**TOWN OF NEWBURGH  
PLANNING BOARD  
TECHNICAL REVIEW COMMENTS**

**PROJECT: DONNELLY-LESLIE ROAD SUBDIVISION**  
**PROJECT NO.: 20-01**  
**PROJECT LOCATION: SECTION 26, BLOCK 6, LOT 25**  
**REVIEW DATE: 28 FEBRUARY 2020**  
**MEETING DATE: 5 MARCH 2020**  
**PROJECT REPRESENTATIVE: ENGINEERING AND SURVEYING PROPERTIES**

**RE: APPLICATION #2020-01  
DONNELLY-LESLIE ROAD SUBDIVISION  
67 LESLIE ROAD  
TAX LOT # 26-6-25**

**SUBDIVISION PLAN**

**C-1**

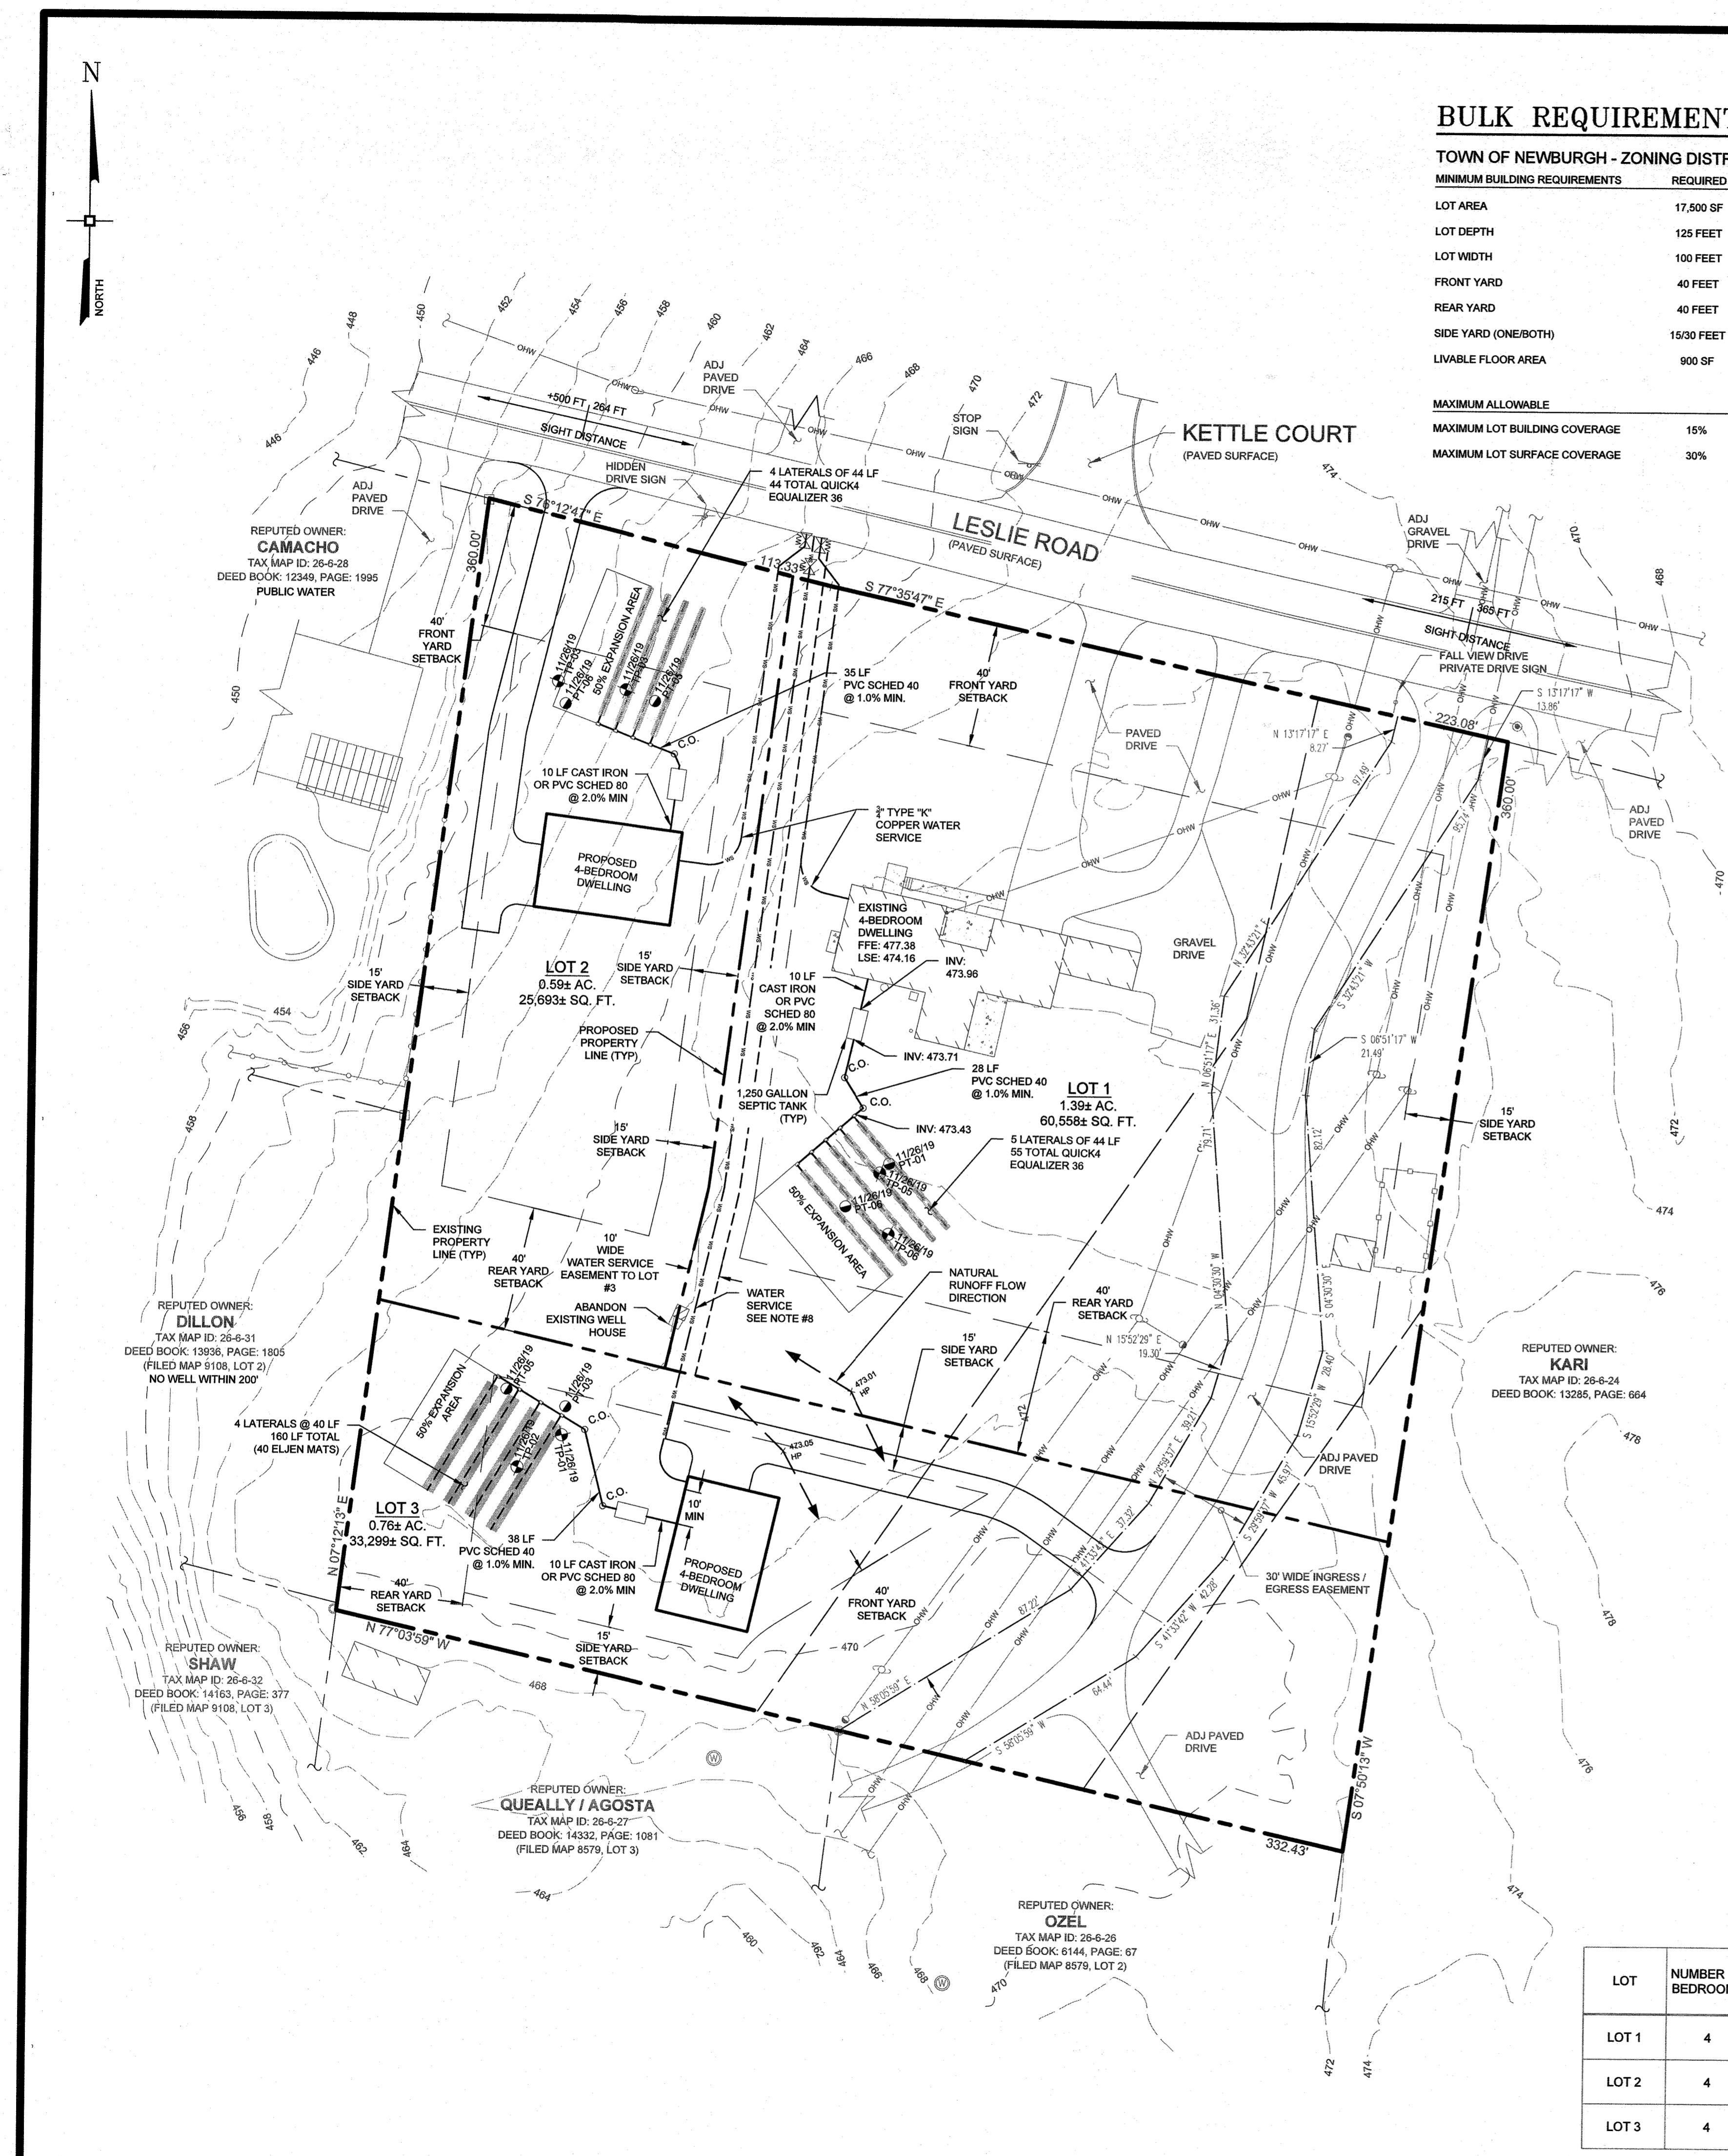
1. According to our client the Highway Superintendent takes no issue with the access road location, as it is an existing access road. Sight distance for the existing access road have been added to the plan which meet the AASHTO minimum standards for stopping sight distance.

4. The proposed utility easement will be provided to the planning board attorney prior to final approval.
5. The design chart has been revised to indicate the 4 equalizer units for lots 1 & 2 while lot 3 proposes the use of eljen units.

13. The design schedule has been revised to indicate 148 linear feet of required eljen units (or 37 eljen mats) in accordance with the eljen design manual. The design provides 160 linear feet of units or (40 eljen mats) which exceeds the minimum required.
